ADDENDUM NO. 3

RE: HIGH SCHOOL #13

High School #13

Howard County Public School System
Bid Number: 016.20.B4

2 SECTION THRU CHILLER ENCLOSURE
A-530 SCALE: 1/2" = 1'-0"

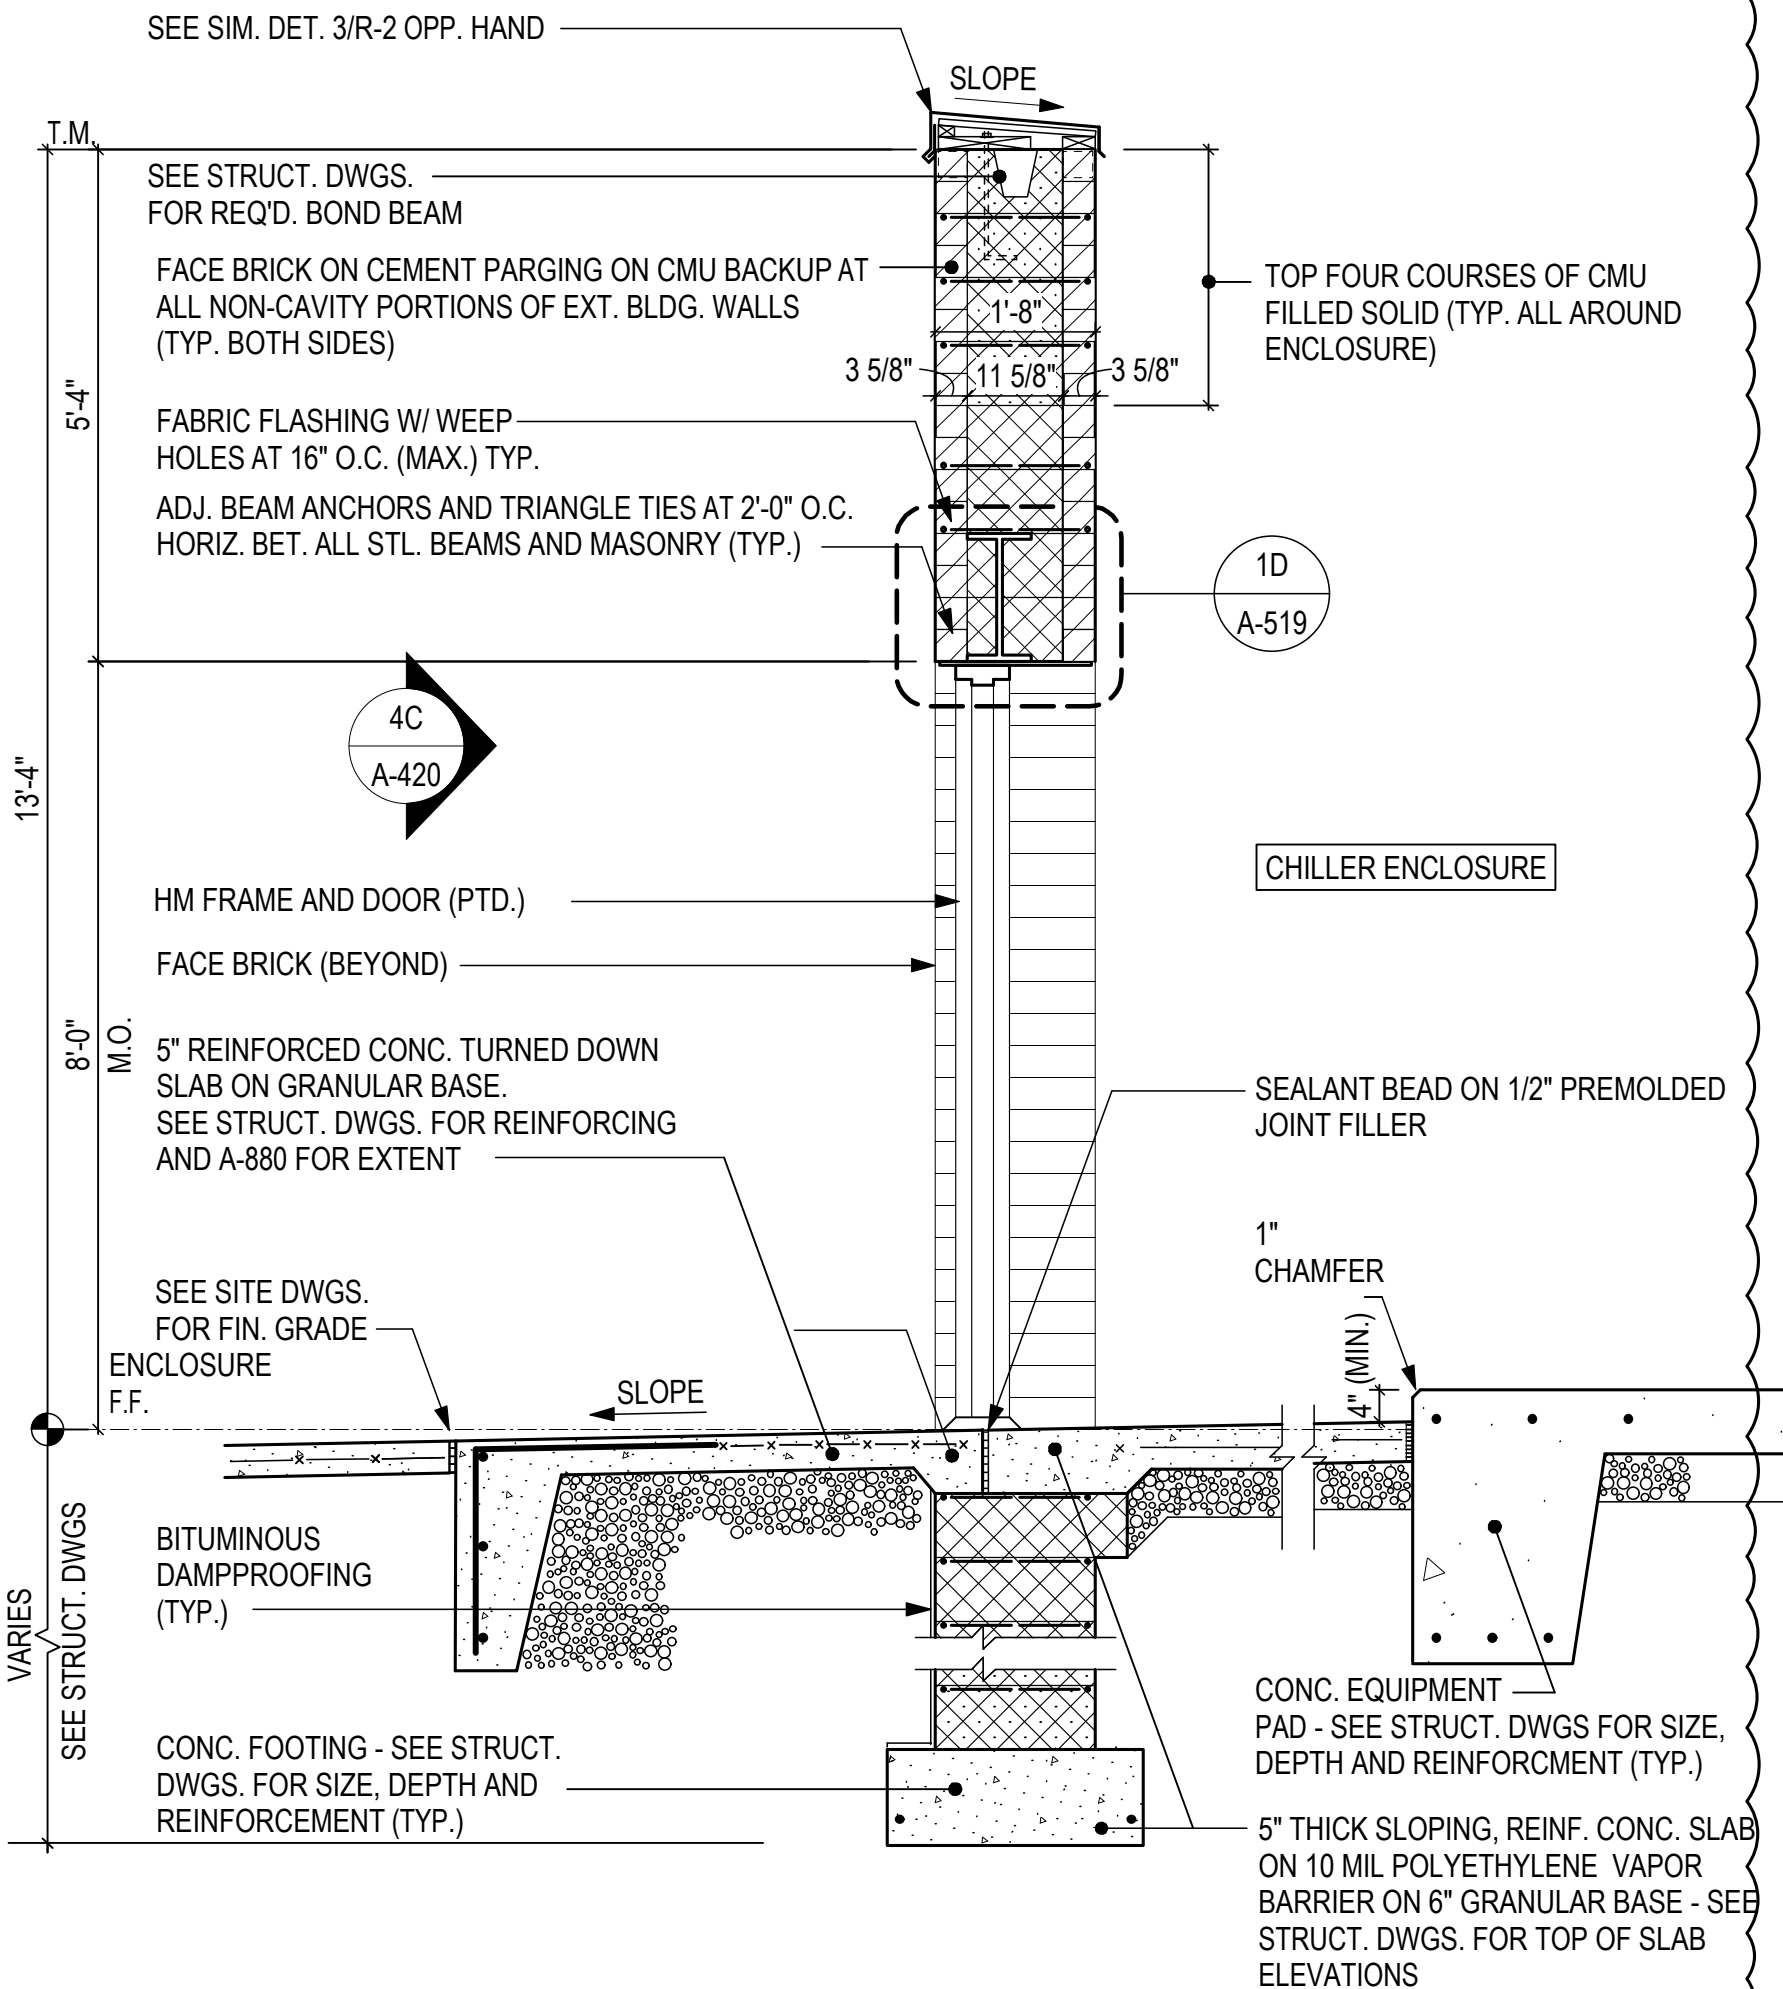
REPLACE Detail 2/A-530 SECTION THRU CHILLER ENCLOSURE as shown on attached sketch ADD_3_A2, dated 18 February 20.

4A PLANK ARRANGEMENT
 NOT TO SCALE

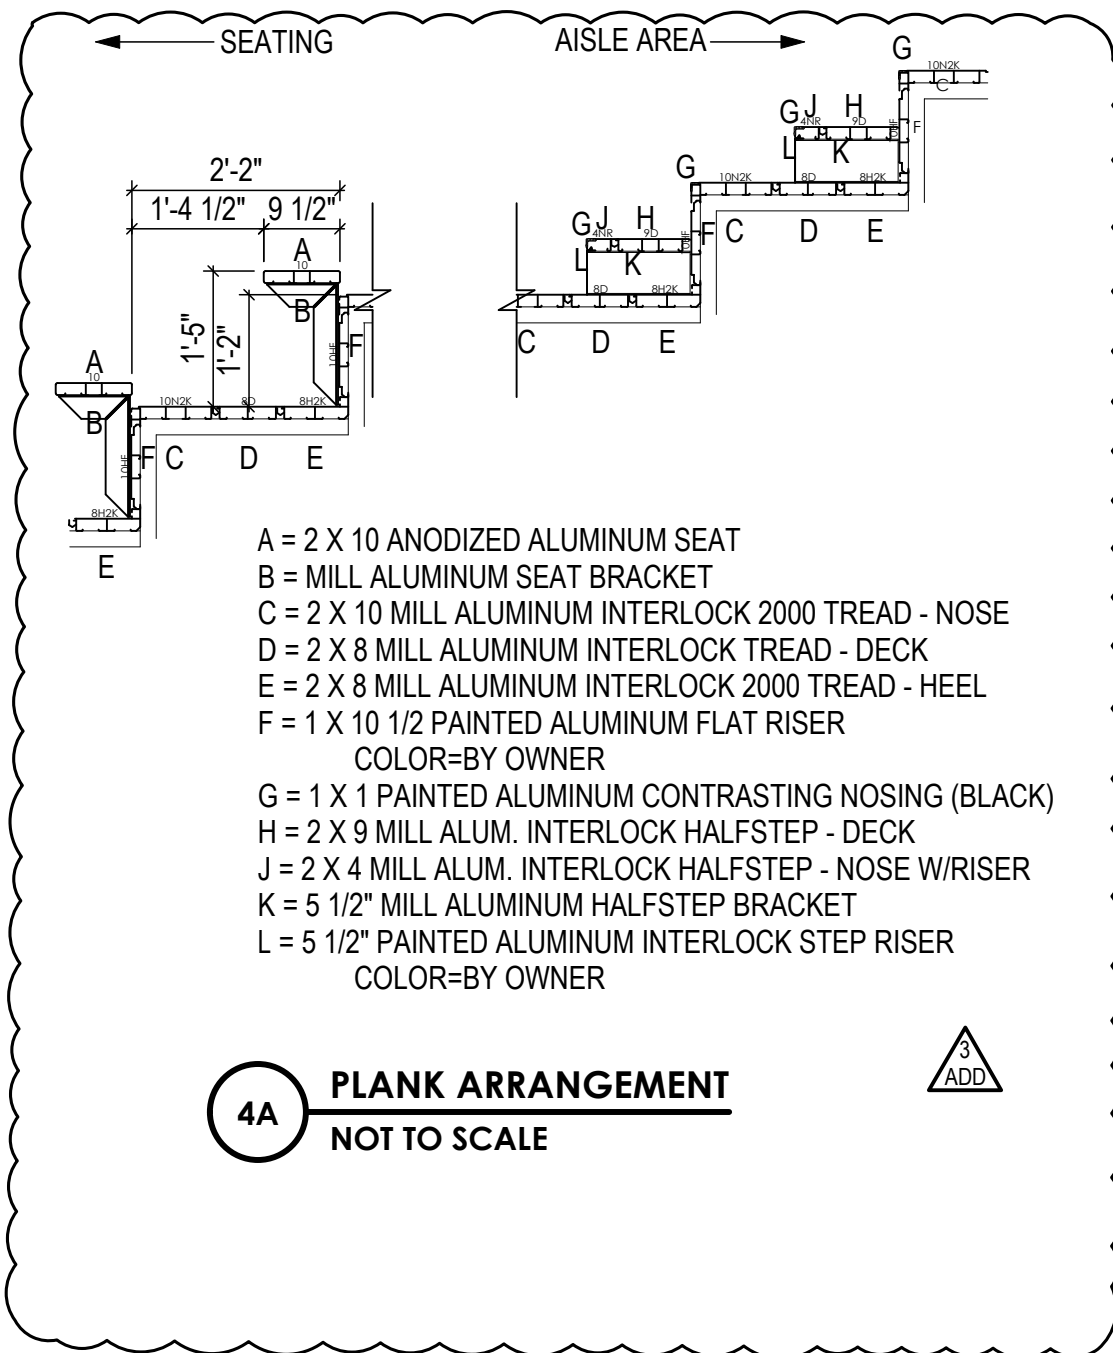
ADD Details 4A and 4C as shown on attached sketch ADD_3_A3, dated 18 February 20.

dwg
ADD_3_A6

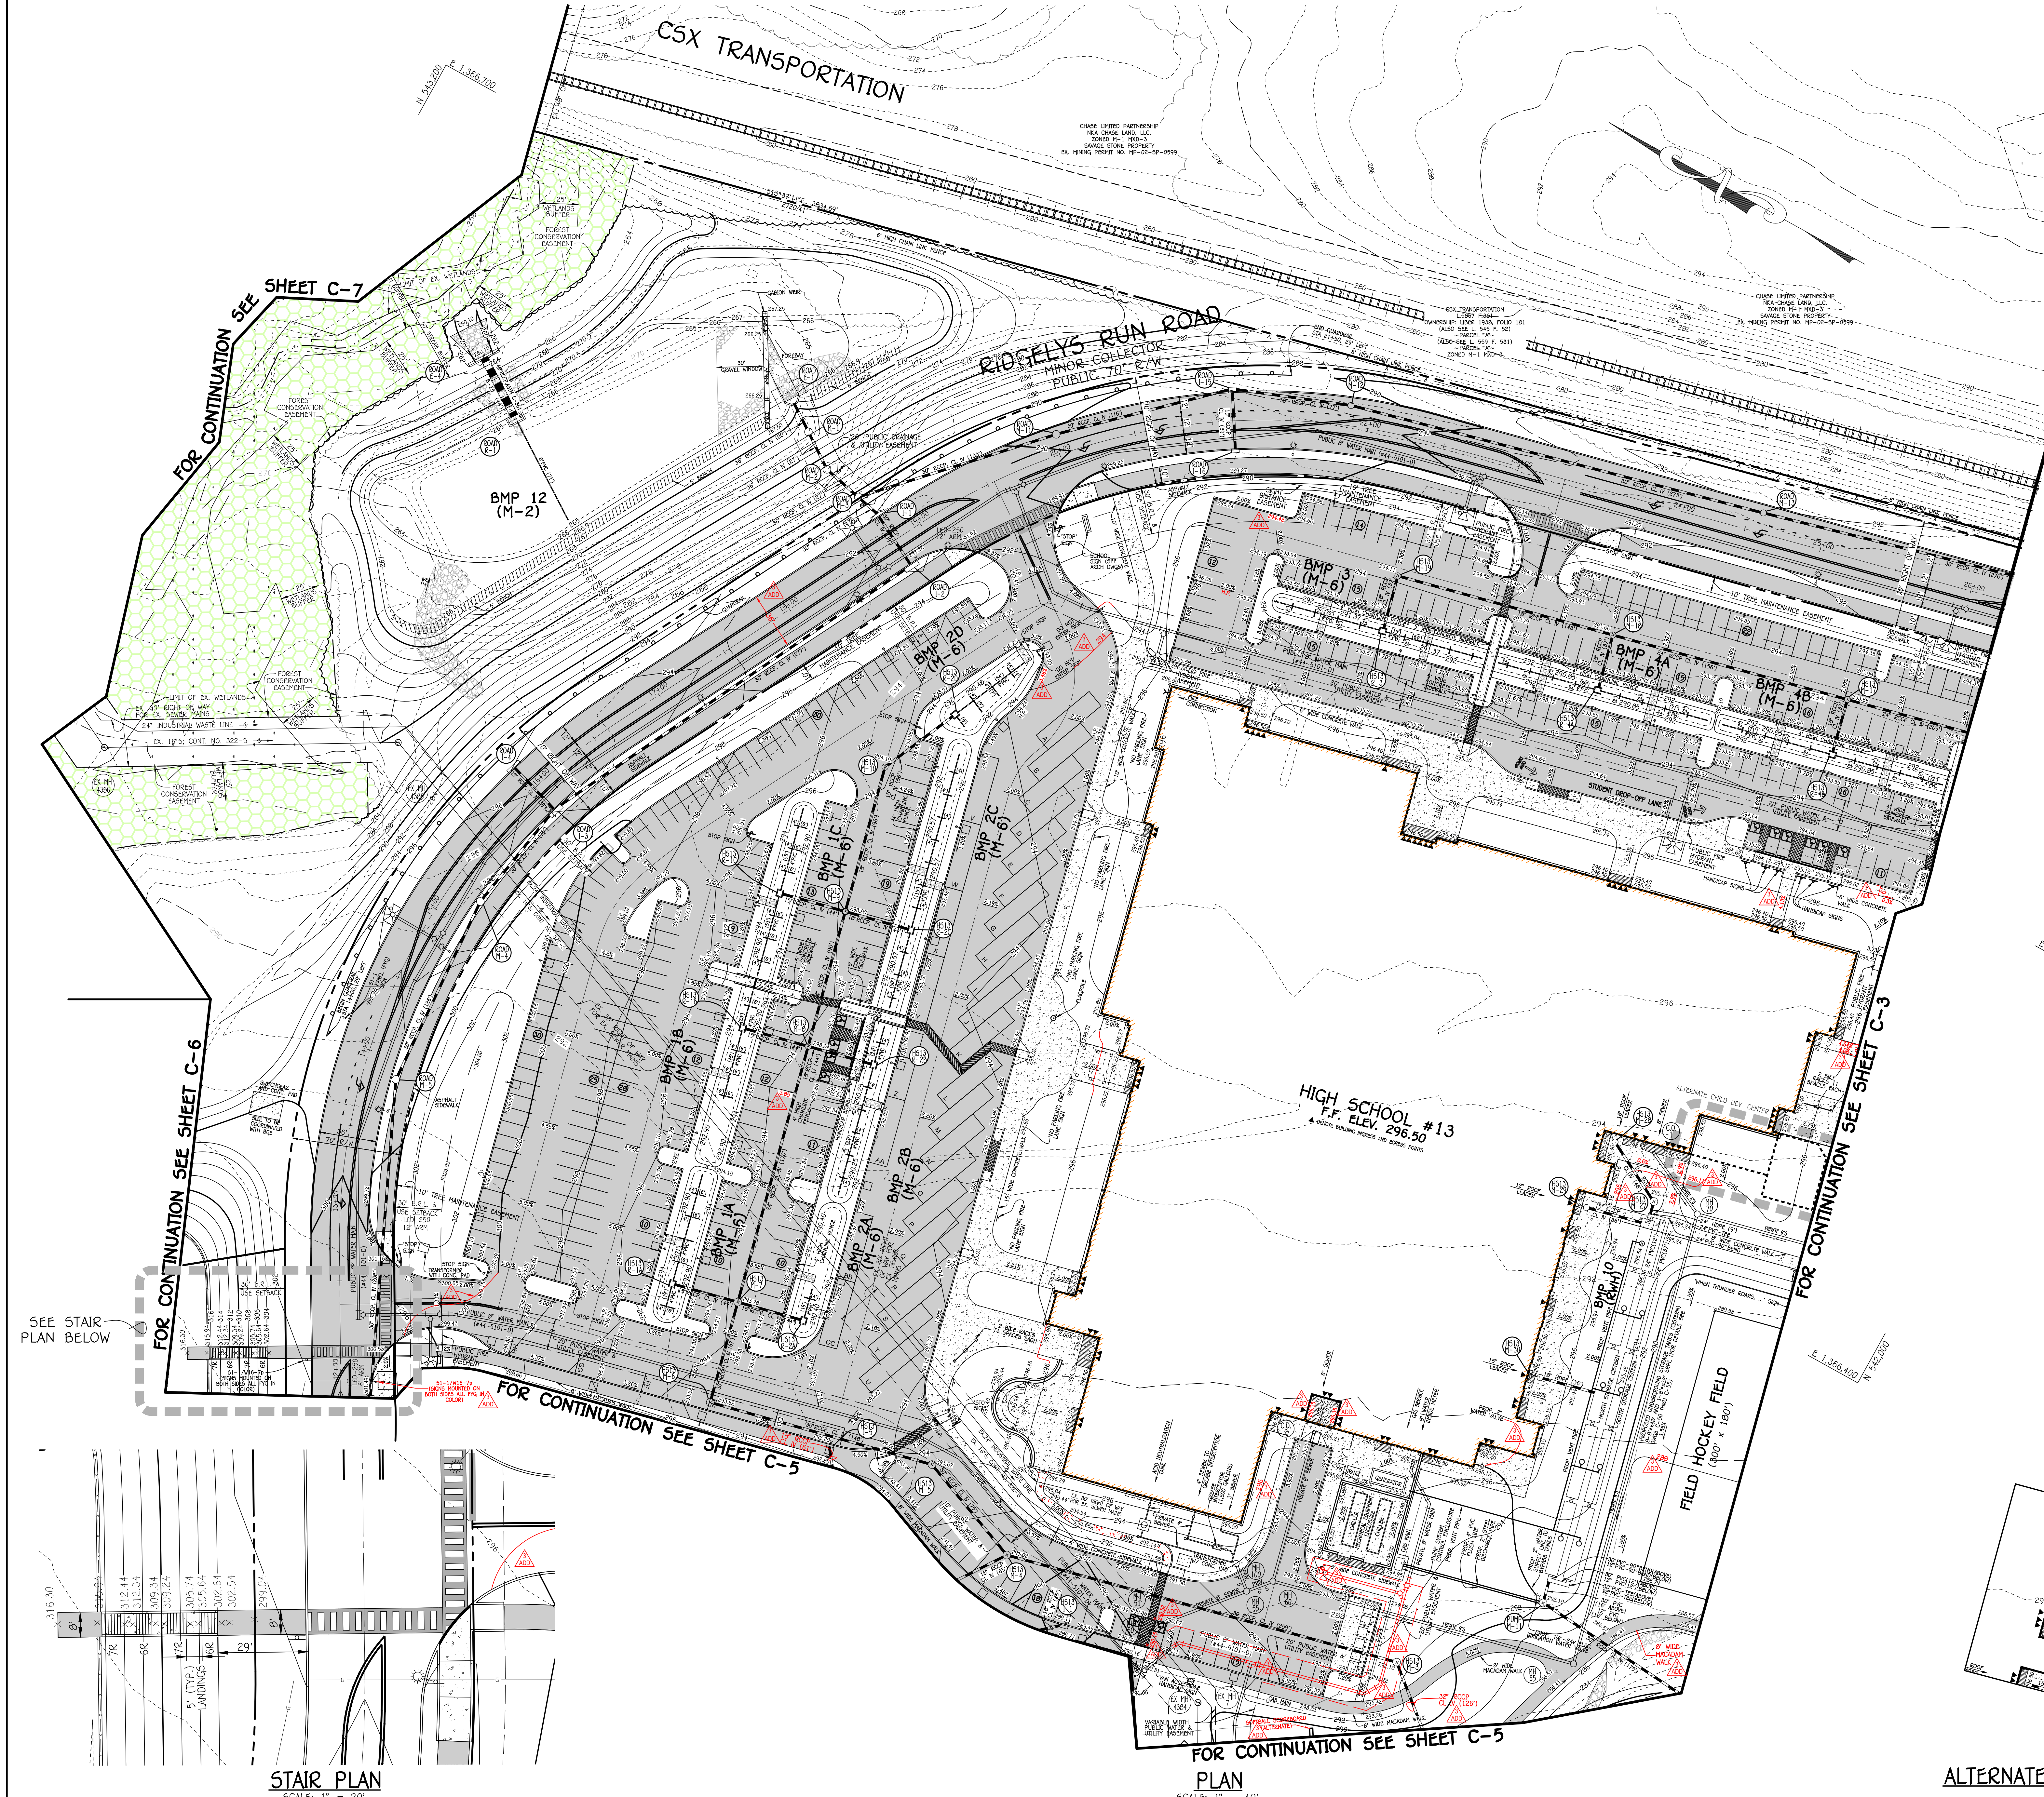
REVISE Team Storage F 901 as shown on attached sketch ADD_3_A6, dated 18 February 20.
